STAFF RECOMMENDATION

1110 Montrose Avenue

September 18, 2019

Description of Project: The application is for the construction of a new infill duplex.

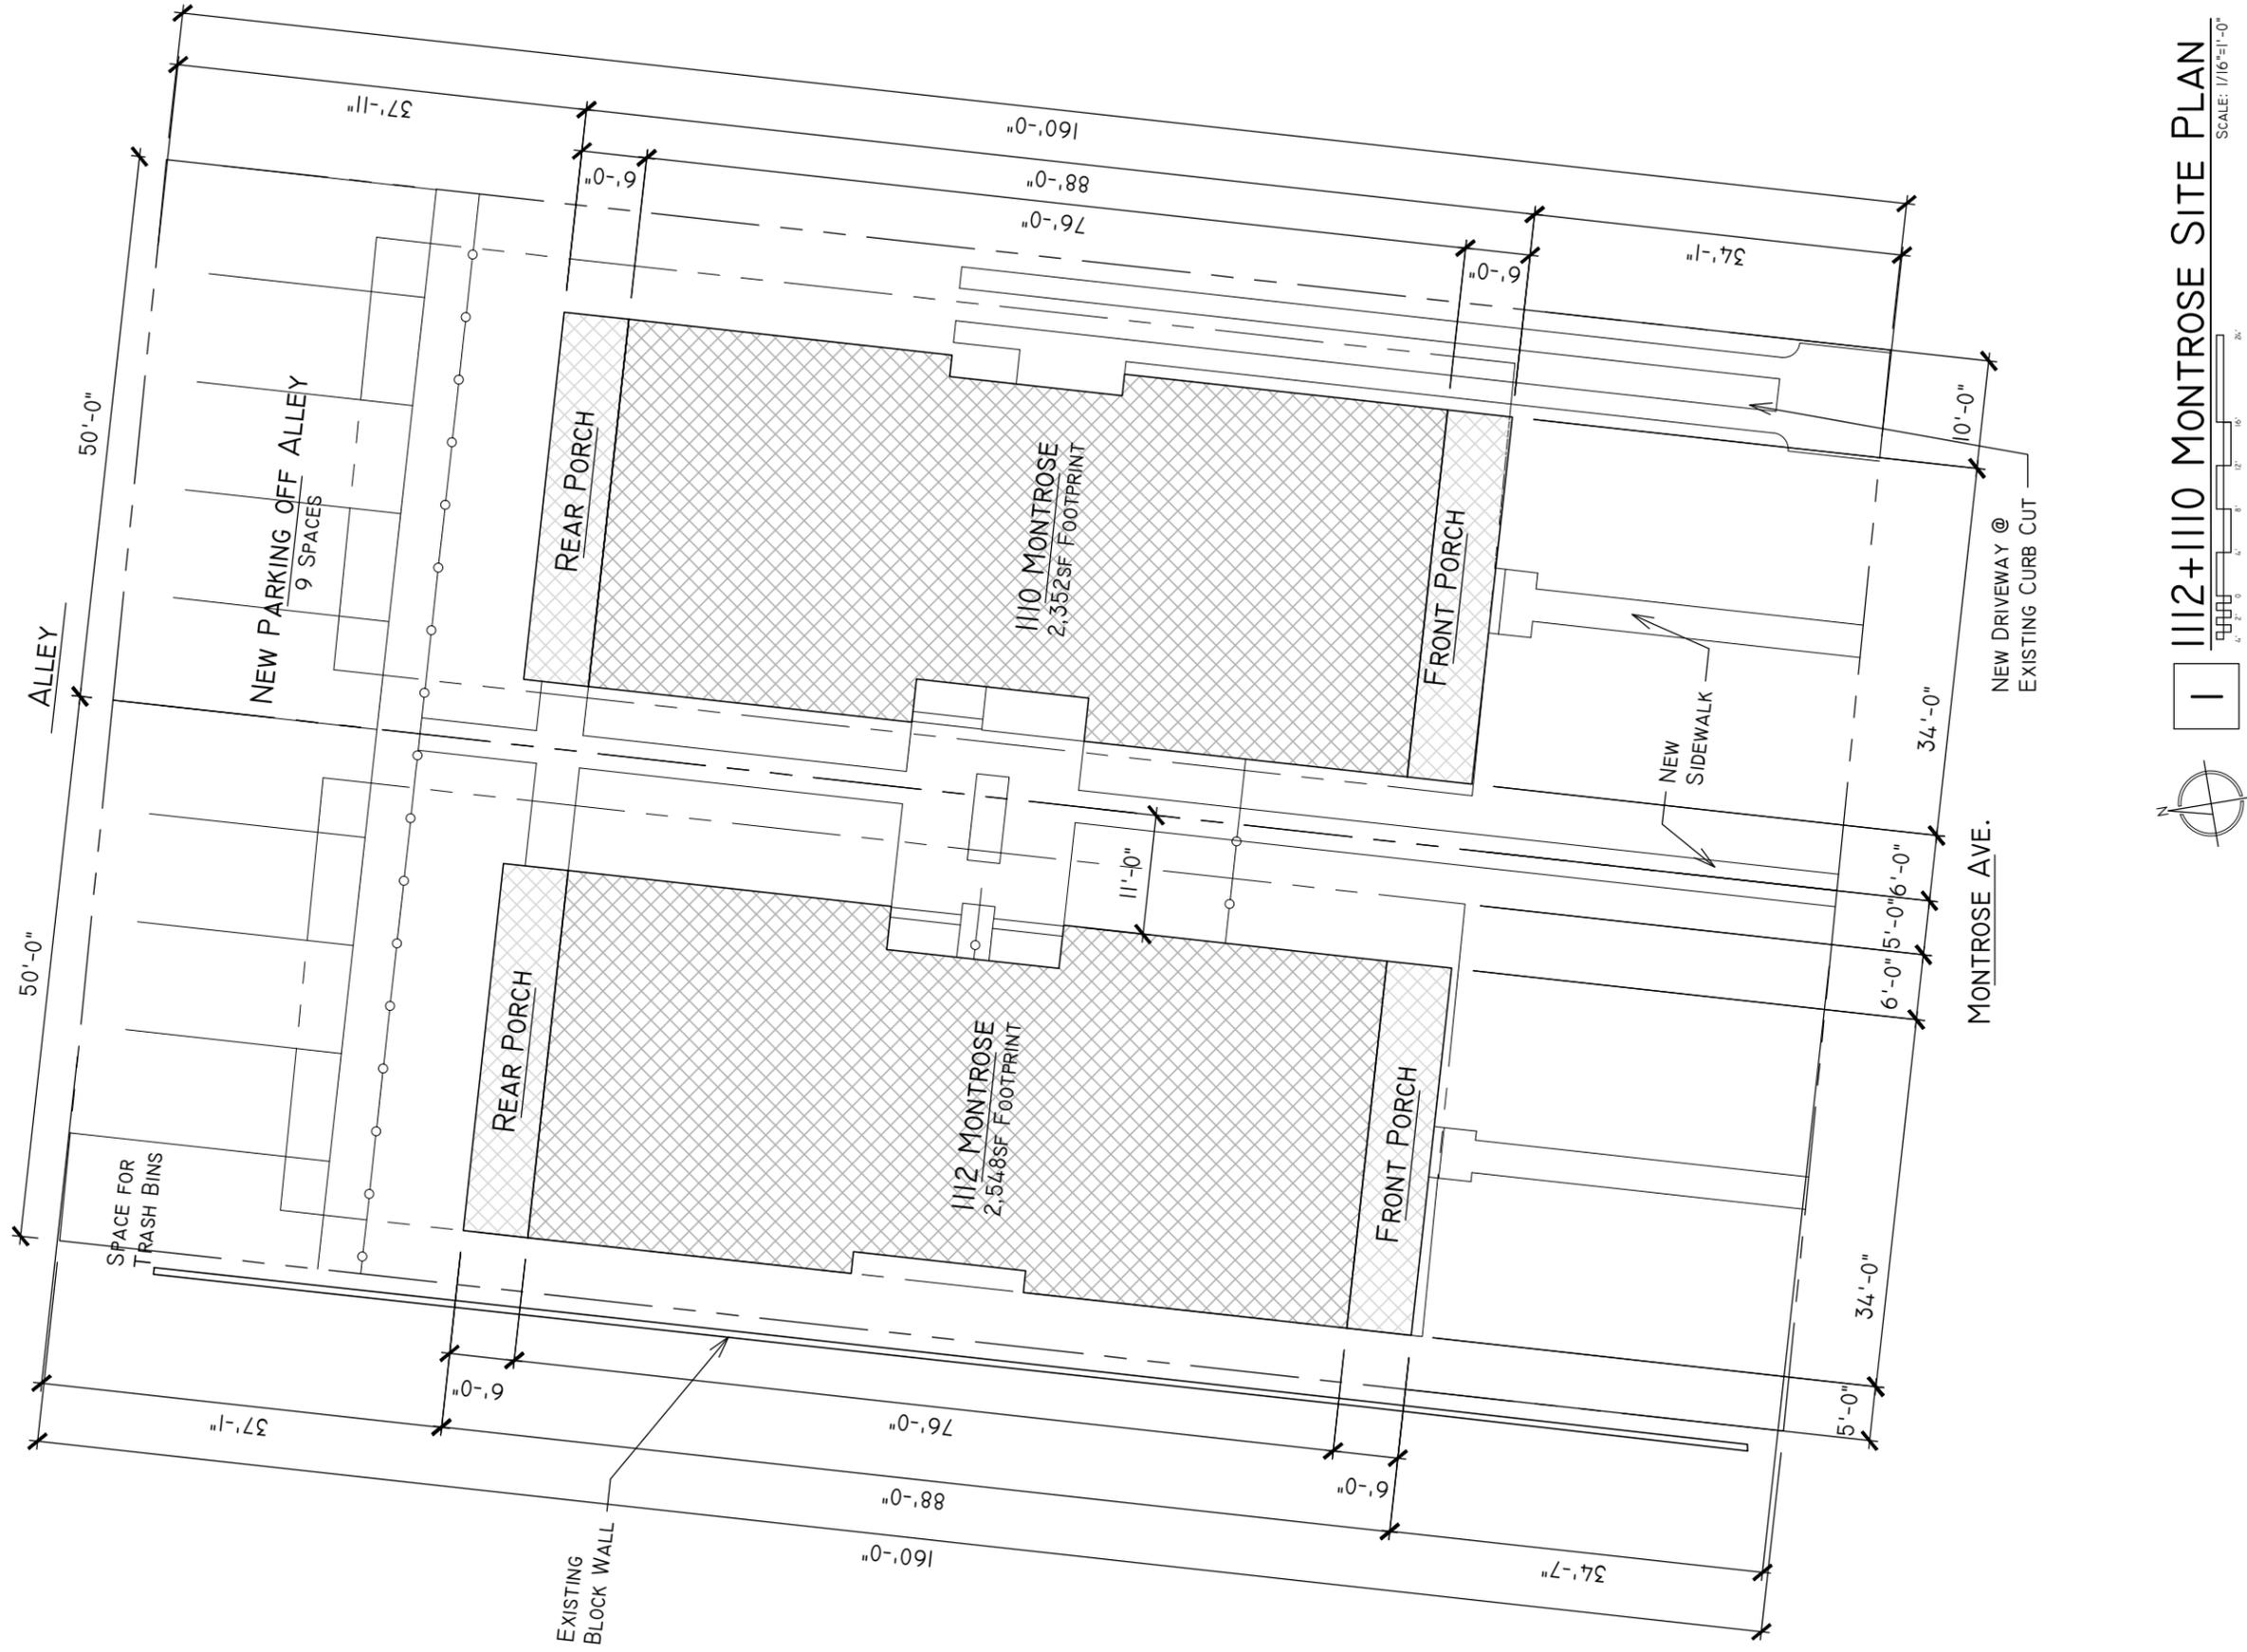
Proportion and Rhythm of Openings: The windows on the proposed building are all generally twice as tall as they are wide, thereby meeting the historic proportions of openings. There are no large expanses of wall space without a window or door opening.

Staff finds the project's proportion and rhythm of openings to meet Section III.G. for new construction-proportion and rhythm of openings.

1 1112+1110 MONTROSE SITE PLAN
SCALE: 1/16"=1'-0"

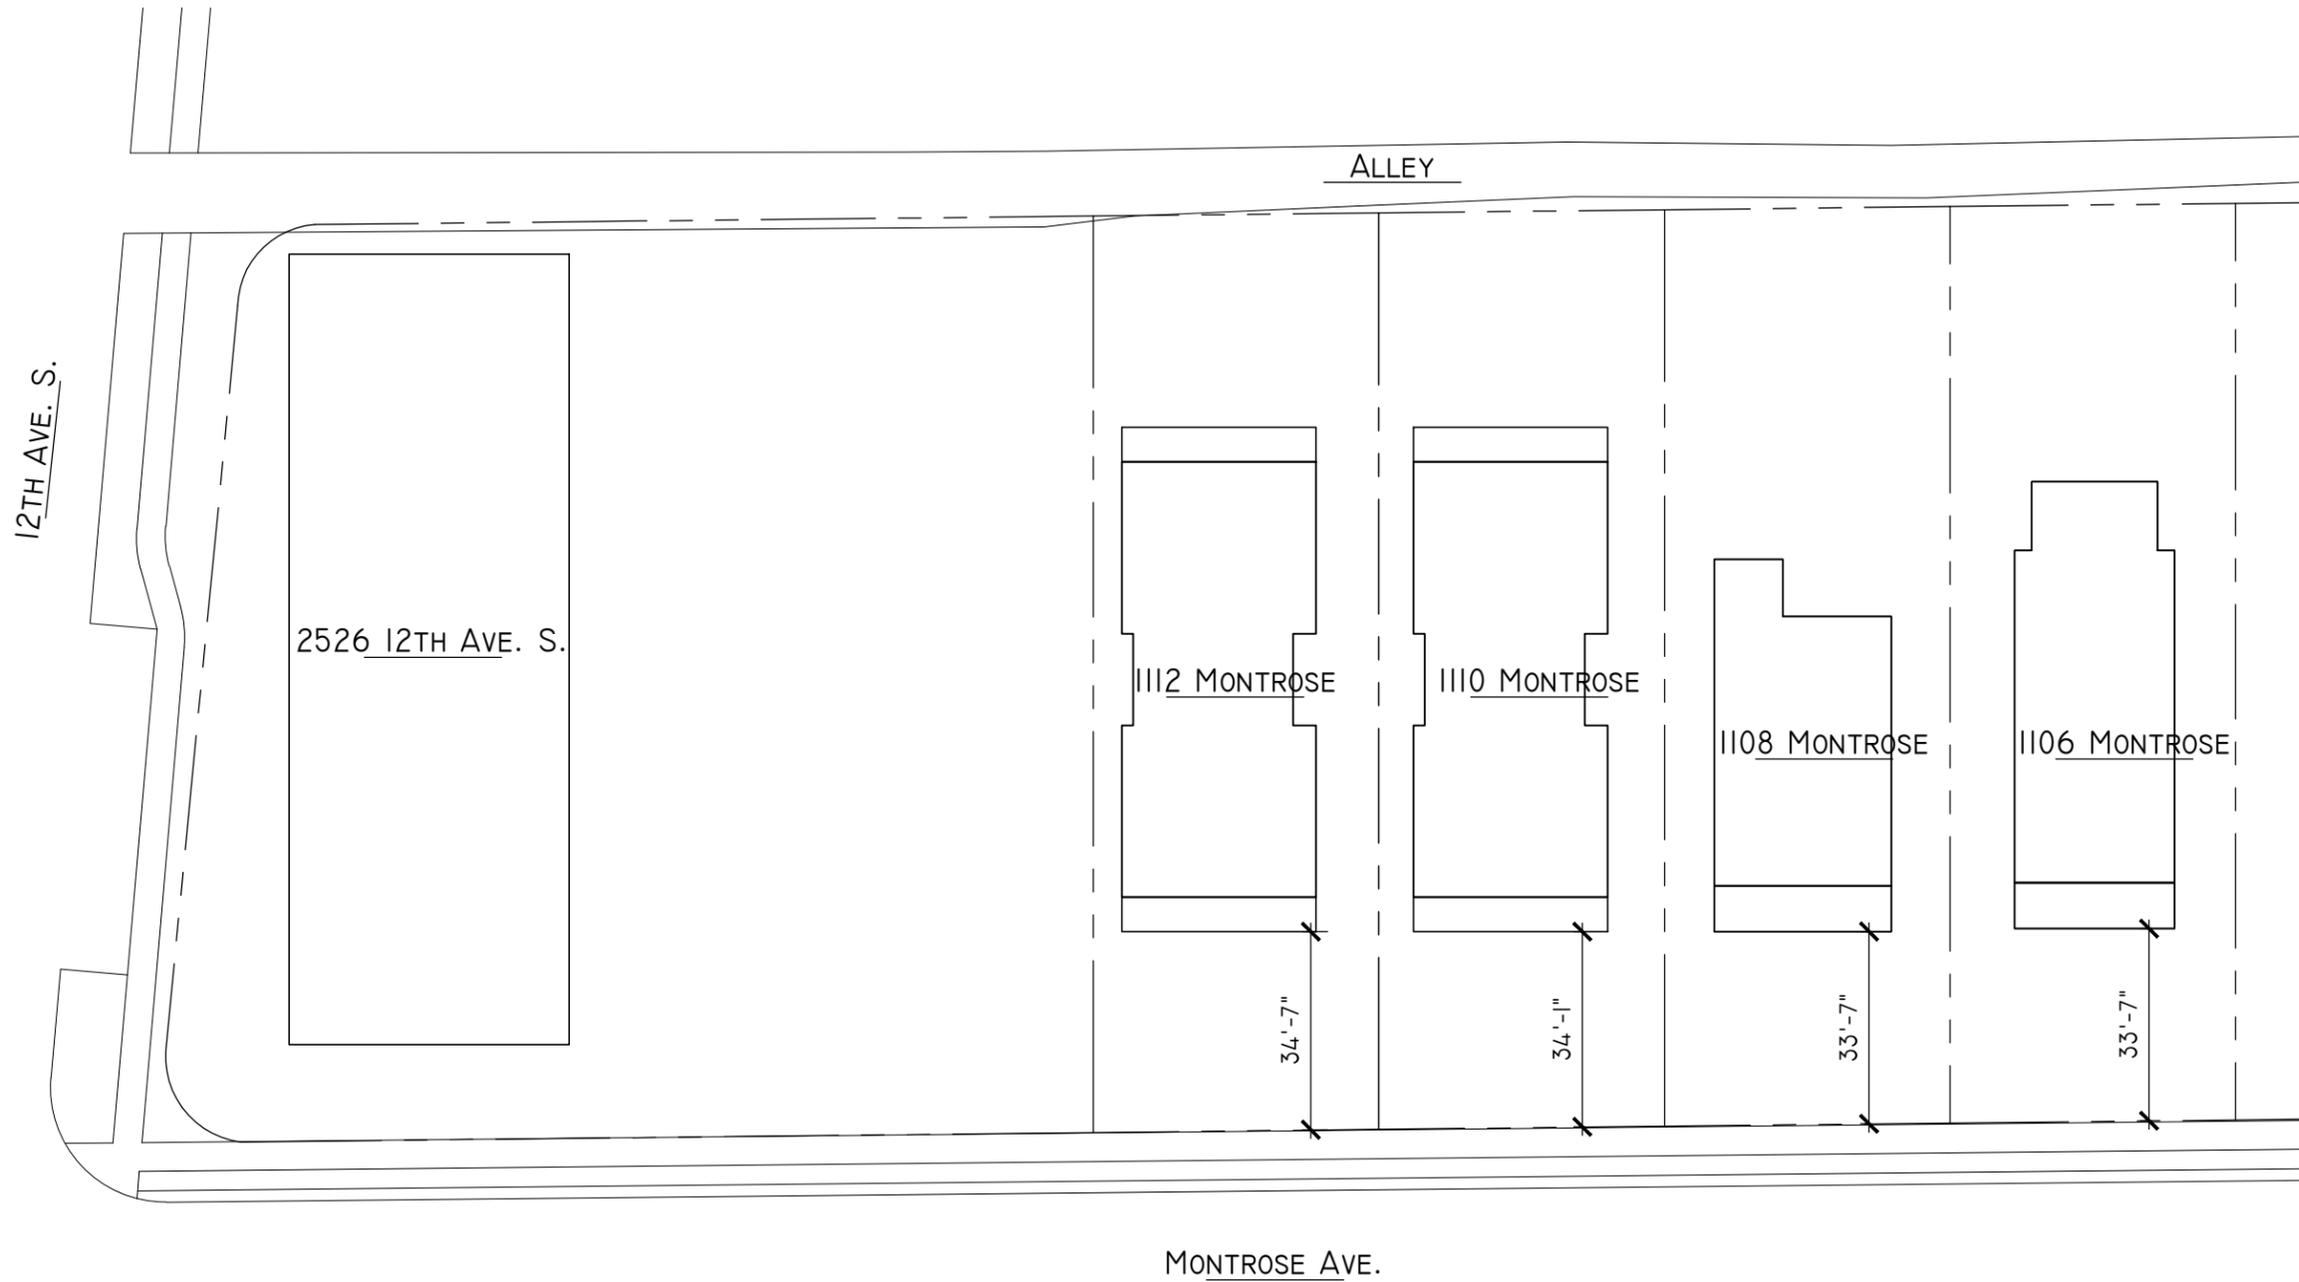
The approved setbacks are not changing.

With Staff review and approval of the front setback in the field, the project meets section III.C for setback and rhythm of spacing for new construction.
